1. 19-0980CA/MA; 110 Riverside Ave (NAC-R, Ward 1E) Sisters & Brothers Investment Group

Reapplication for 57 unit apartment building with underground parking. (Project Manager: Mary O'Neil)

To: Development Review Board
From: Mary O'Neil, AICP, Principal Planner
Date: July 16, 2019
RE: ZP19-0980CA/MA, 110 Riverside Avenue

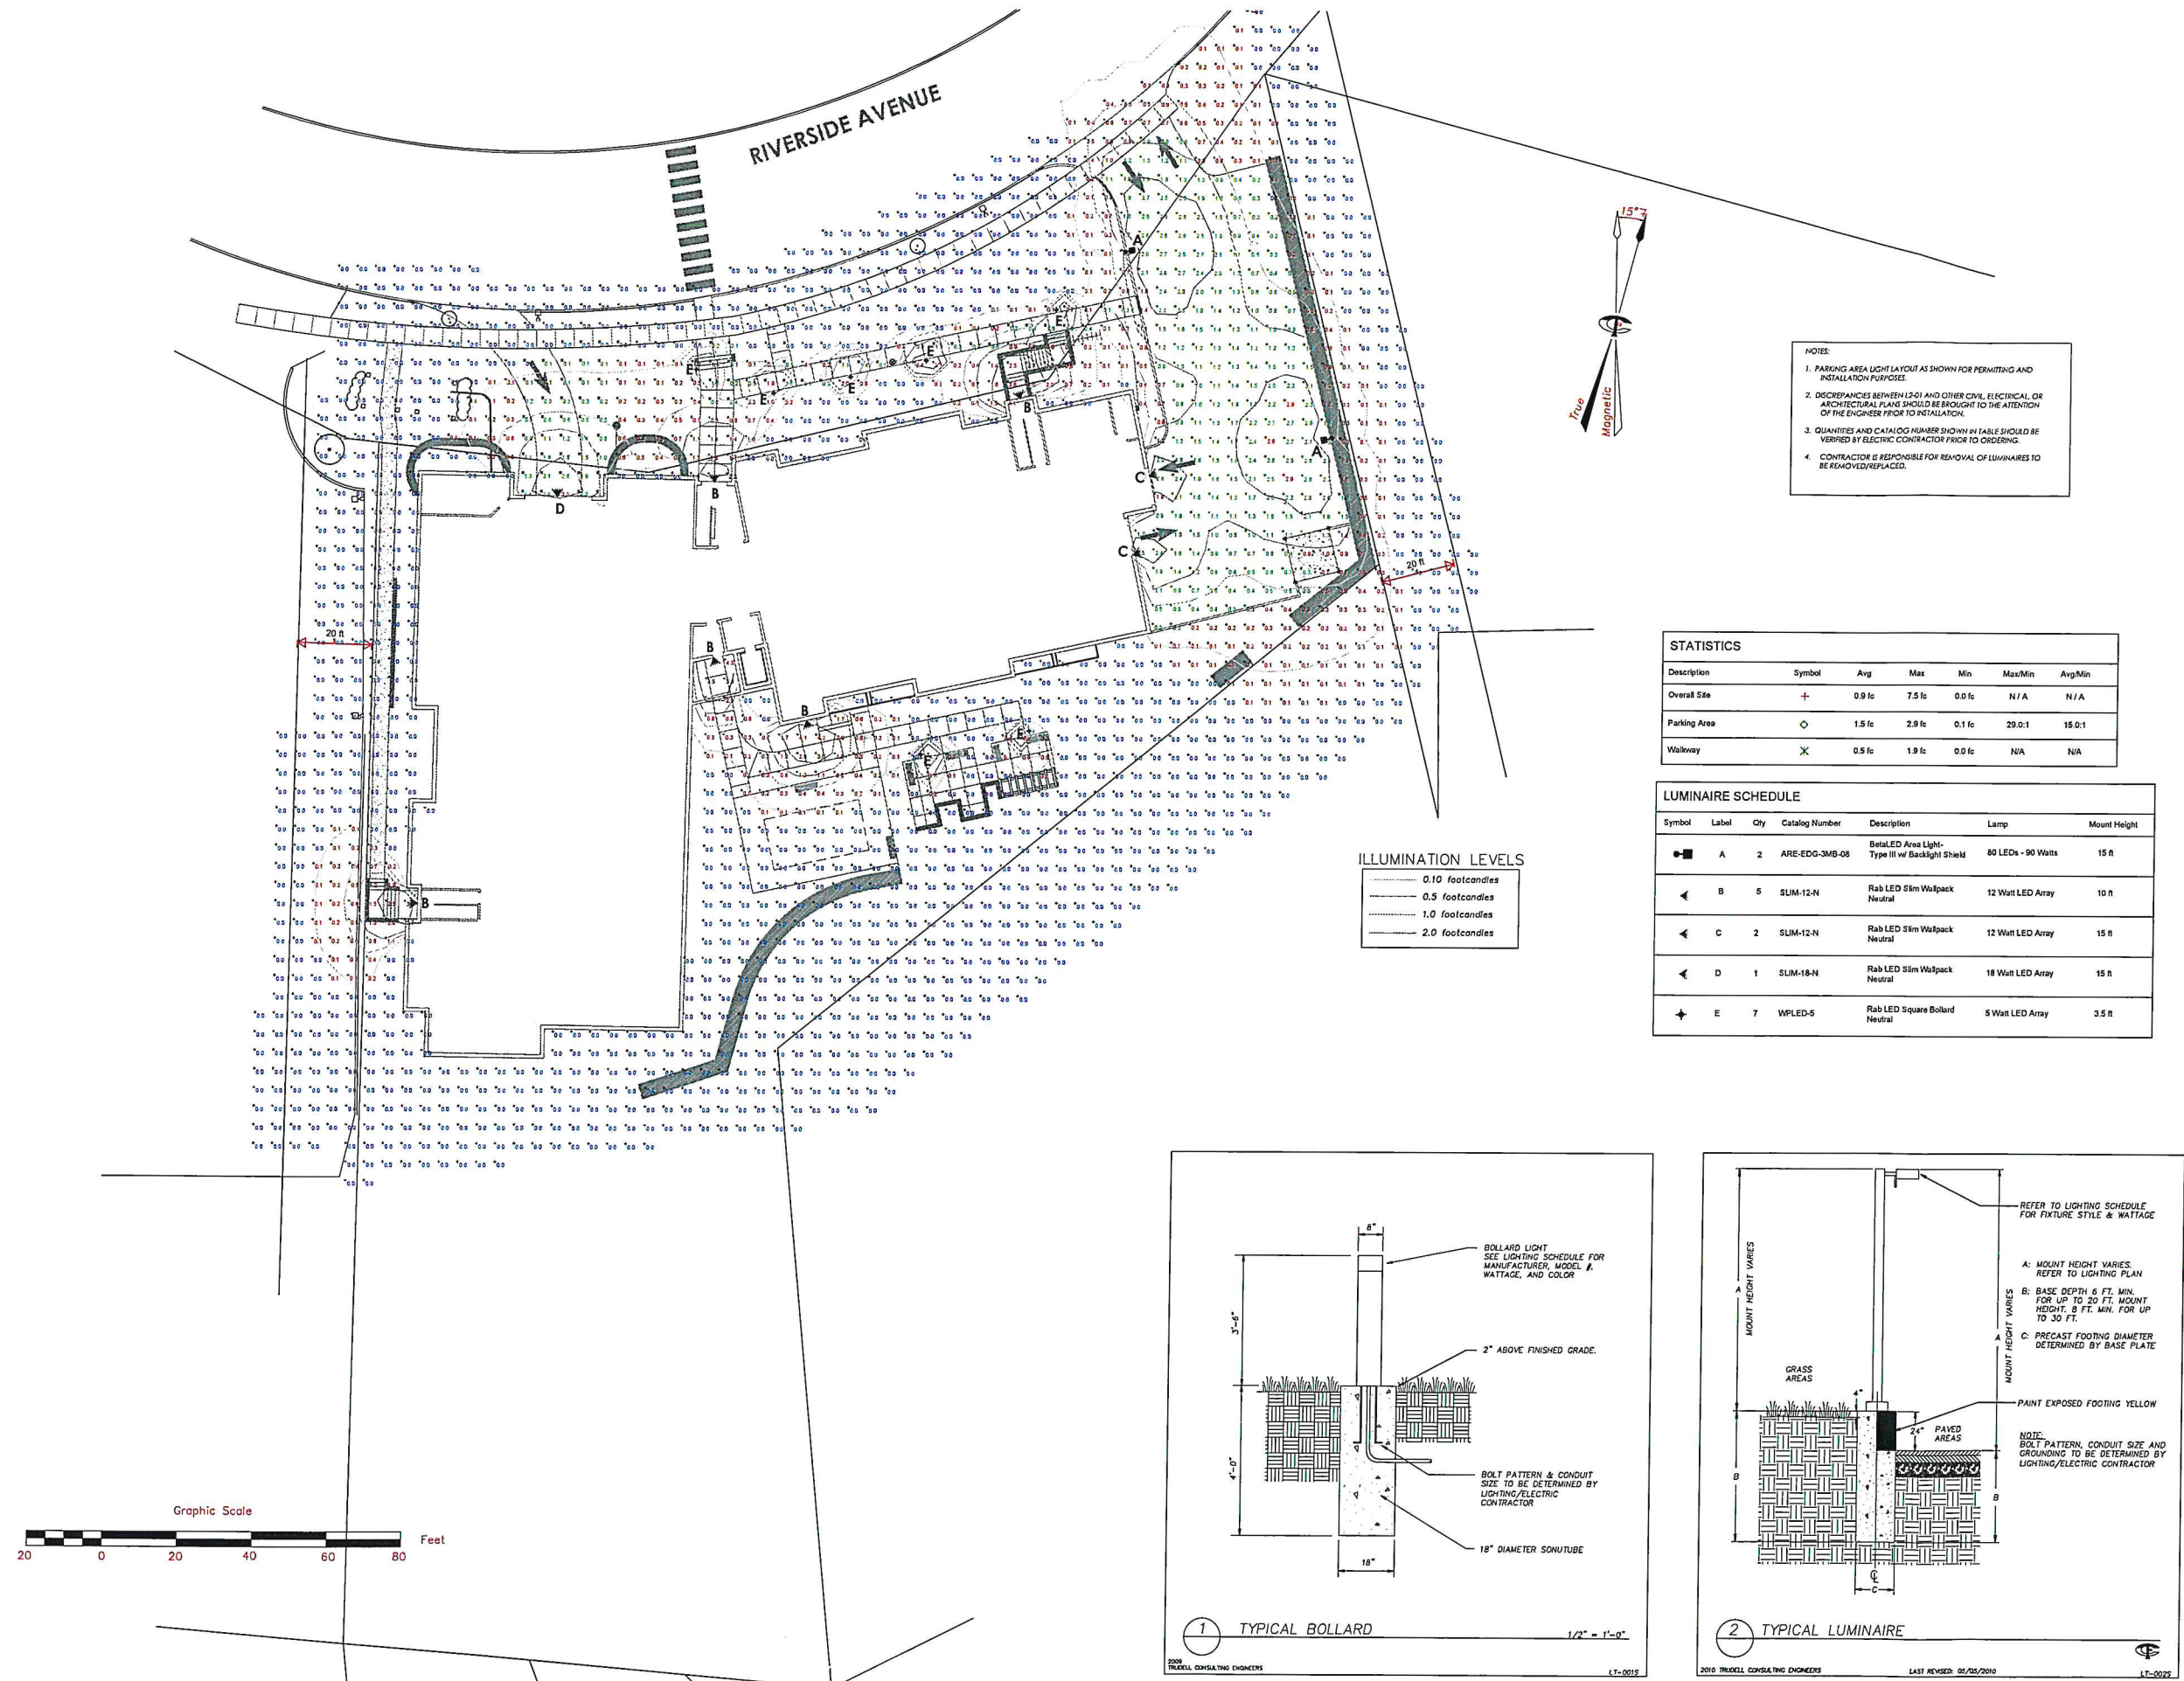
The submitted photometric plan includes several lighting measurements on the northerly boundary exceeding the .1 threshold 20' outside the property boundary. Walkway lighting also exceeds 2.0 fc in several places (particularly under the "B" fixtures. No average illumination schedule has been provided; no max/min calculation as well; both are required. Revision of the lighting plan, with the noted omissions shall be a condition of approval. **Affirmative finding as conditioned.**

A detail on the lighting plan (L2-01) indicates "Mounting height varies..." This standard limits maximum mounting height for any fixture to 25' **Affirmative finding as conditioned.**

C. *The maximum to minimum uniformity ration shall not exceed 20:1.* The reported ratio was 15:1 per the detail on the 2013 plan L2-01. The detail is omitted in current submission materials, and is required. **Affirmative finding as conditioned.**

C2-01

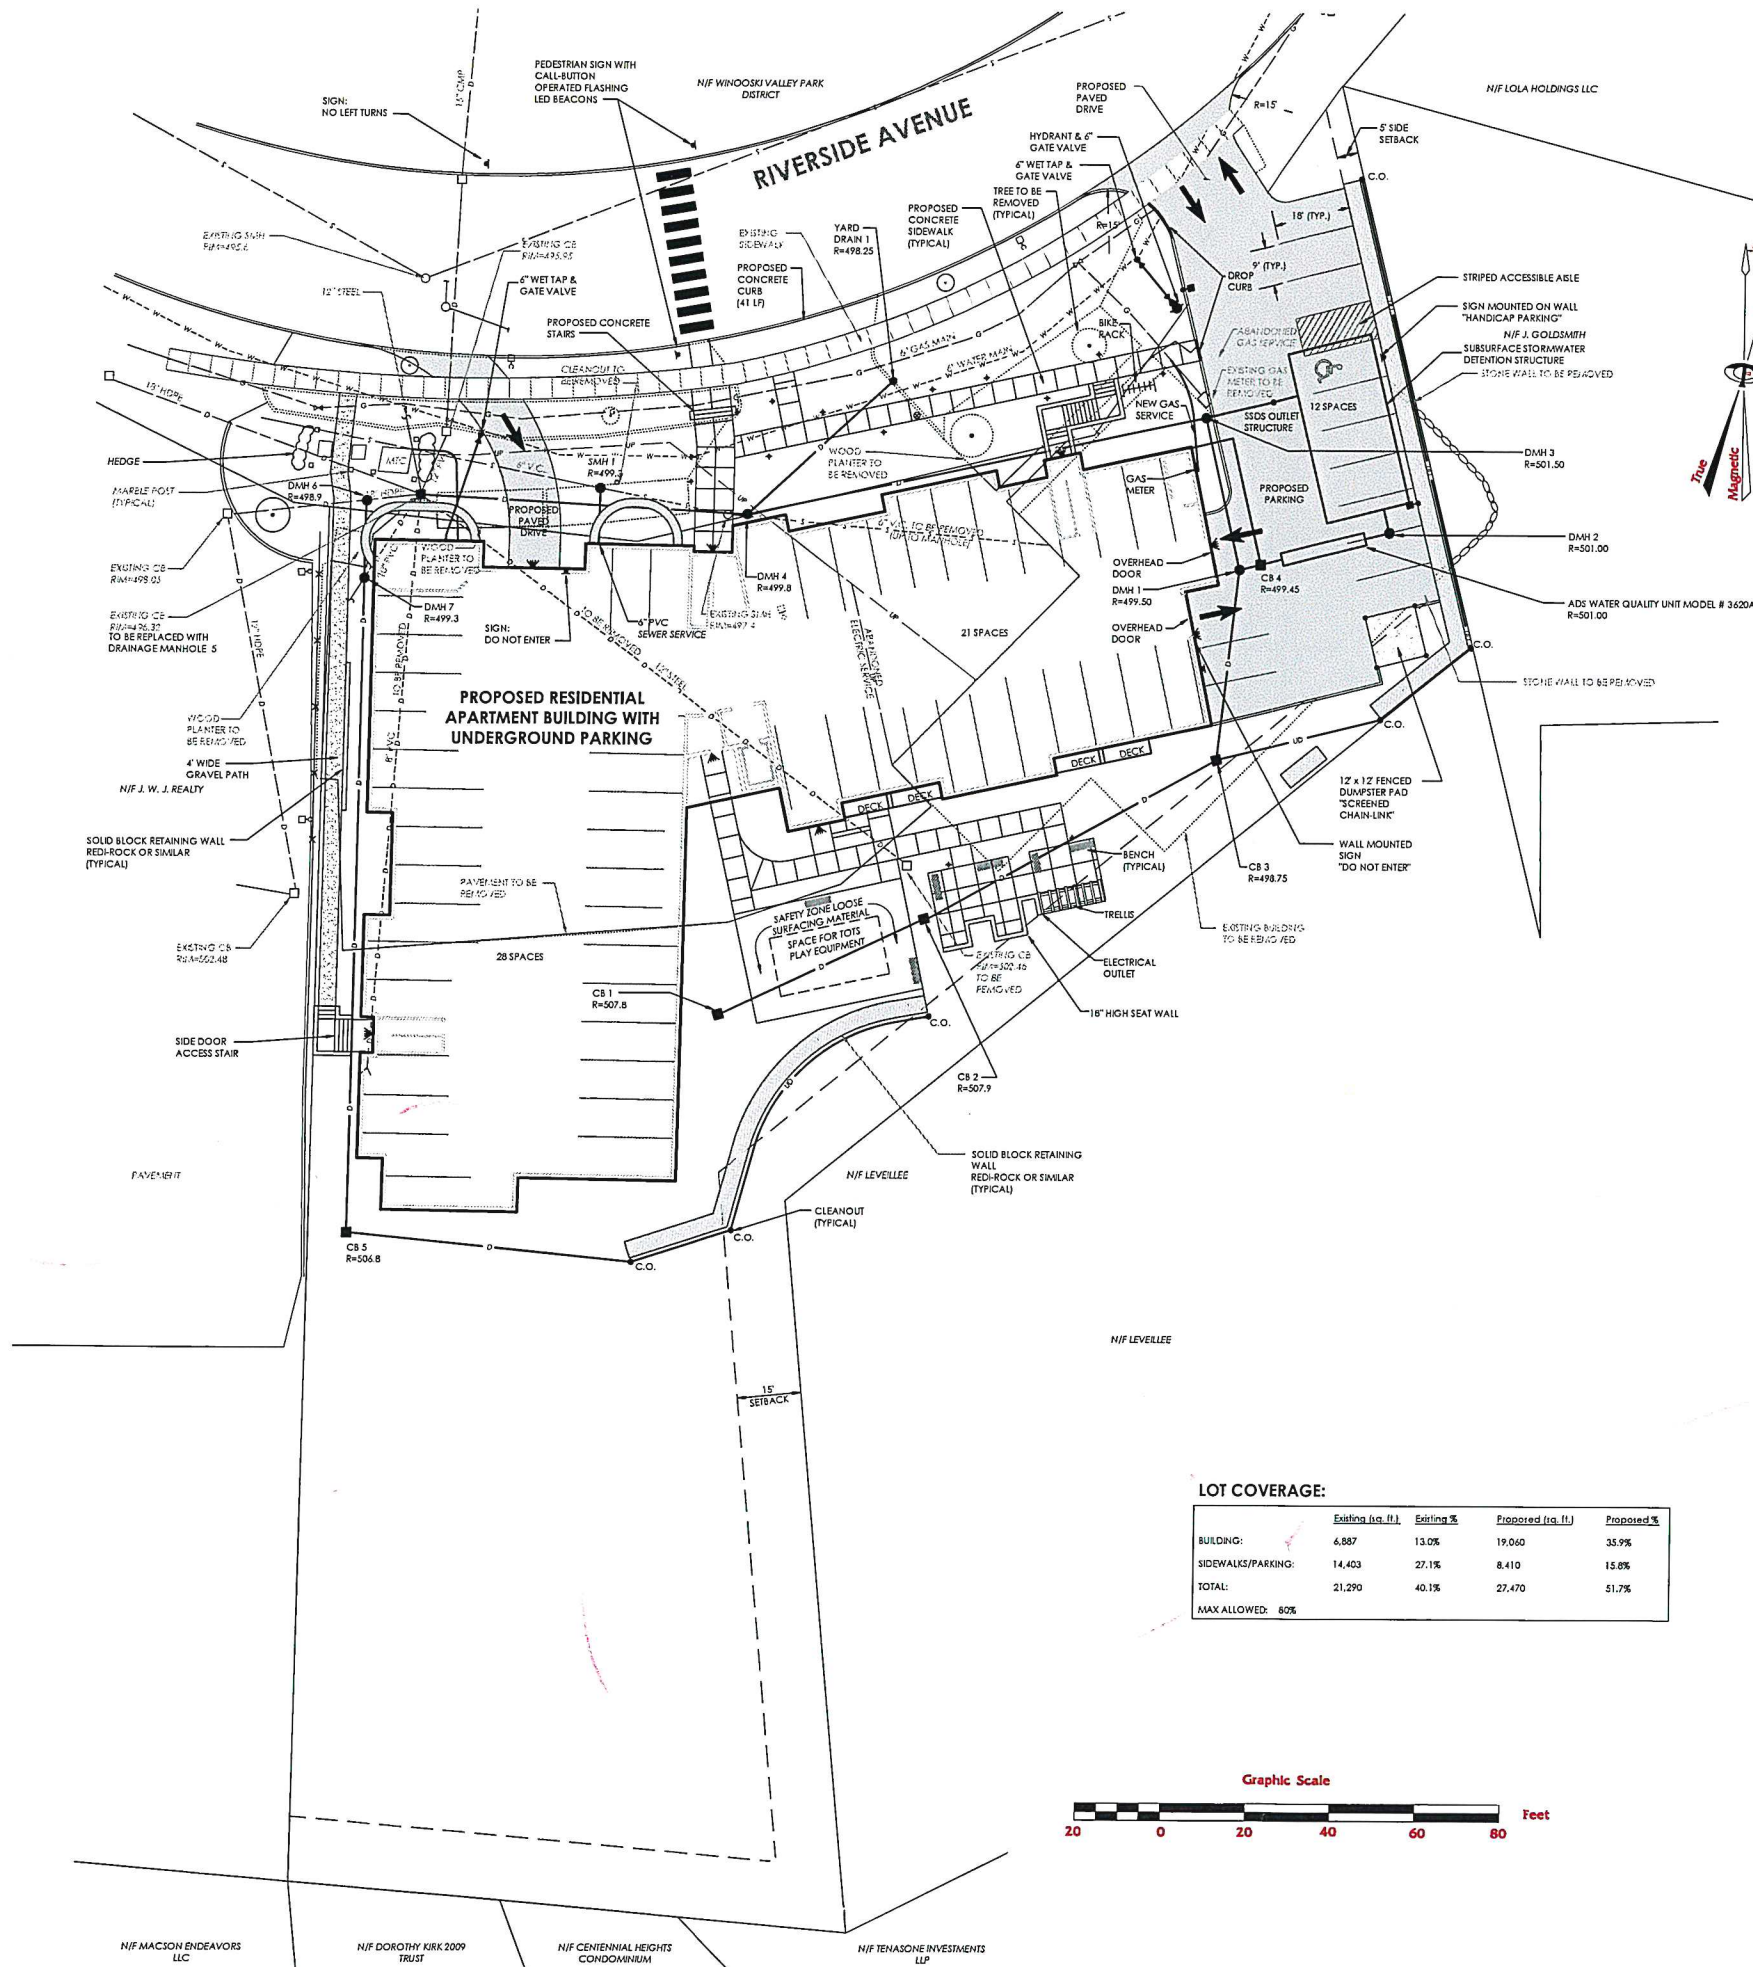
For a site of 53,143 square feet (provided on the Engineer's Plan, C2-01), the maximum FAR allowance would be 159,429 sq. ft. (Bonus max 3.0 FAR.) The application proposes 88,772 (69,499 total gross floor area of the building, 19,273 surface parking = 88,772); or 1.67 FAR.

A list of proposed plantings and a landscaping plan has been submitted. The C2-01 site plan notes removal of a tree fronting Riverside Avenue and removal of wood planters and stone wall.

Utility meters/connections shall be illustrated on site plans and building elevations. Plan C2-01 notes removal of existing gas meter; the new location is on the north/east corner of the building. No plan for screening the meter has been provided, and needs to be identified.

C5-01

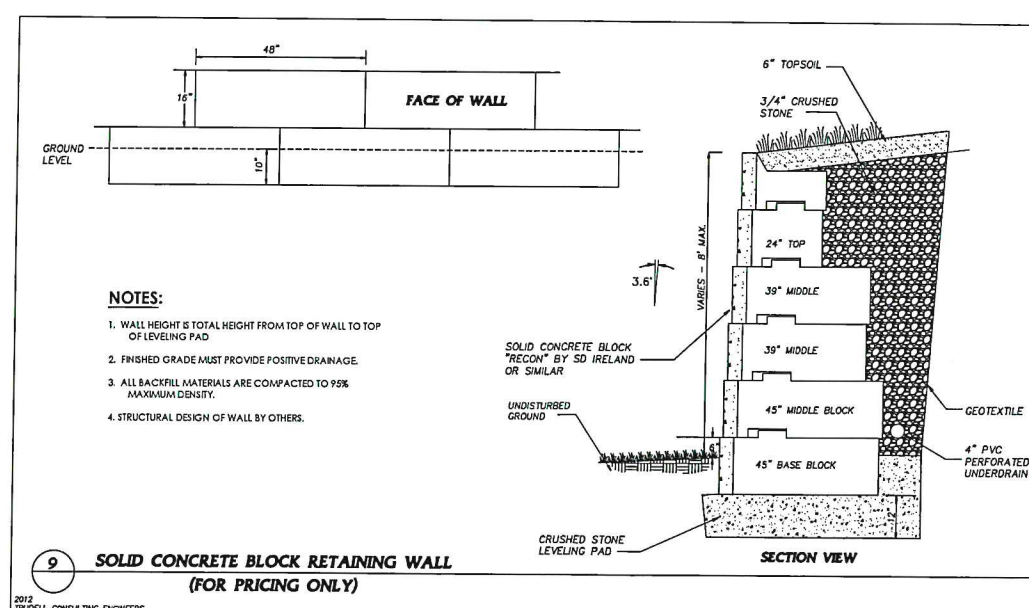
The limits of the tree clearing are identified on Plan 5-01. This is particularly important, given the steep slope and potential for erosion at the rear of the site. An email from Trudell Engineering notes that they have contacted Knigh Consulting to work with this project relative to steep slopes, as they did the original geo exploration in 2012 and made recommendations for slope stabilization and sheeting. **Affirmative finding as conditioned.**

There is an existing and significant embankment that rises at the rear of the site. Any application should include information relative to the protection, stabilization, engineered development, or avoidance of the steep grade. A Grading Plan has been provided as part of this application (C2-02.) As site drainage is expected to be altered, confirmation and approval of the City Stormwater Administrator will be essential. As previously noted, a tree clearing area has been identified on Plan C5-01. **Affirmative finding as conditioned.**
